# SERVICE BULLETIN BUG

B-019 May 17, 1999

### SAFETY RECALL CODE 0811 - S1 AND S1W NEGATIVE BATTERY CABLE

Figure 1. Fuel Tank (\$1 Shown)

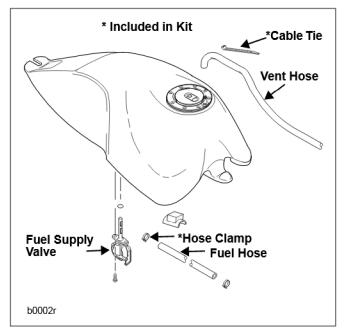
- See Figure 1. Remove hose clamp from fuel hose from fuel supply valve.
- 8. Cut cable tie and remove vent hose from fuel tank vent.
- Remove fuel cell and set on a carpeted surface to avoid cosmetic damage.

Figure 2. Negative Battery Cable

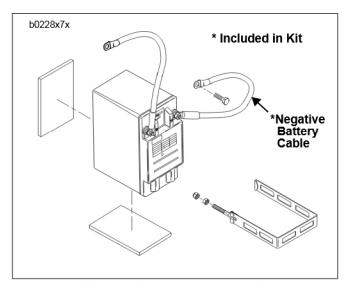
- Visually inspect the negative battery cable coming from the left (-) side of the battery. Inspect for the following:
  - HD Part Number 70461-67B and lot number printed on cable.
  - · Shiny heat shrink on both ends
  - Silver-colored soldered wires visible at the terminals

- See Figure 2. Disconnect negative (-) battery cable from battery terminal.
- Disconnect negative (-) battery cable from frame.
  Remove and discard original negative (-) battery cable.
- 12. Install **new** negative battery cable supplied with kit to frame with existing hardware. Tighten bolt to 10 ft-lbs (13.6 Nm). Use care when routing cable to avoid contact between cable and circuit breaker.
- Install **new** negative battery cable supplied with kit to negative (-) battery terminal with existing hardware Tighten battery cable bolt to 30-40 **in-lbs** (40.7-54.2 Nm).
- Install tail section with two TORX bolts and nylon washers. Tighten TORX bolts to 72-96 in-lbs (8.1-10.8 Nm).
- 15. See Figure 1. Install **new** hose clamp to fuel hose and fuel supply valve.
- Install vent hose to fuel tank vent with cable tie supplied in kit
- 17. Install fuel tank.
